Access Compliance Report

Public Rights-of-Way

(Curb Ramps)

Intersection ID: 9339	Main Street: WOODWARD_AV	Cross Street: TRANQUIL_OAK_PL	Location: NW
ADA ID: 2CEBB42354B6	Ramp Type: Perp	Initial Pass/Fail: Pass	Overall Compliance: No
			Severity Score: 15.25

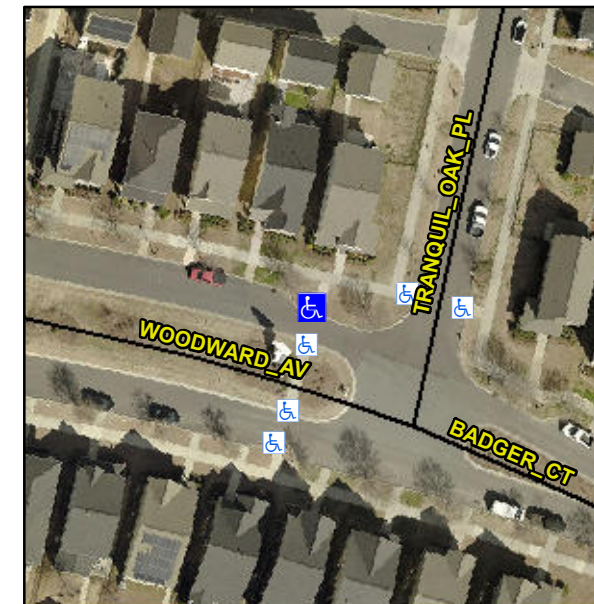
Compliance	Description	Data	Compliance	Description	Data
N/A	Ramp Length (in)	206.0	Yes	Ramp Slope (%)	5.3
Yes	Ramp Width (in)	59.0	No	Ramp XSlope (%)	3.5
Yes	Flare Type L	Curbed_NoWalkSurface	Yes	Flare Type RT	N/A
Yes	Flare Slope LT (%)	N/A	N/A	Flare Slope RT (%)	N/A
N/A	Flare Traversable LT?	No	N/A	Flare Traversable RT?	No
Yes	Landing Length (in)	71.0	Yes	DWS Provided?	Yes
Yes	Landing Width (in)	69.5	Yes	DWS Contrast?	Yes
No	Landing Slope (%)	2.7	Yes	DWS Length (in)	24.0
No	Landing X Slope (%)	7.3	Yes	DWS Full Width?	Yes
N/A	Landing Curb? (Y/N)	No	No	DWS Offset (in)	4.0
N/A	Shared Landing?	No			
Yes	Gutter Ponding?	No	Yes	Gutter Slope (%)	0.7
No	Gutter Lip Ht (in)	1.0	No	Gutter X Slope (%)	3.5
N/A	Painted X Walk1?	No	N/A	Painted X Walk2?	N/A
	X Walk 1 Direction	To S		X Walk 2 Direction	N/A
N/A	X Walk 1 Width (in)	N/A	N/A	X Walk 2 Width (in)	N/A
	X Walk 1 Slope (%)	1.1		X Walk 2 Slope (%)	N/A
	X Walk 1 X Slope (%)	2.7		X Walk 2 X Slope (%)	N/A

N/A	Ramp inside XWalk1?	N/A	N/A	Ramp inside XWalk2?	N/A
	Road Slope (%)	N/A	N/A	Clear Space?	Yes
	Road X Slope (%)	N/A	N/A	Clear Space to XWalk (in)	N/A
Yes	Any Obstructions?	No	Yes	Storm Grate/Utility Hazard?	No
	Obstruction Type			Storm Grate/Utility Type	
		N/A			N/A
			Yes	Surface Condition? (G/P)	Good

**Remove & Replace Entire Ramp.
Remove & Replace Gutter.**

**R304.5.3, R304.2.2-Perp, R304.3.2-
Para, R305.2, R302.7.2**
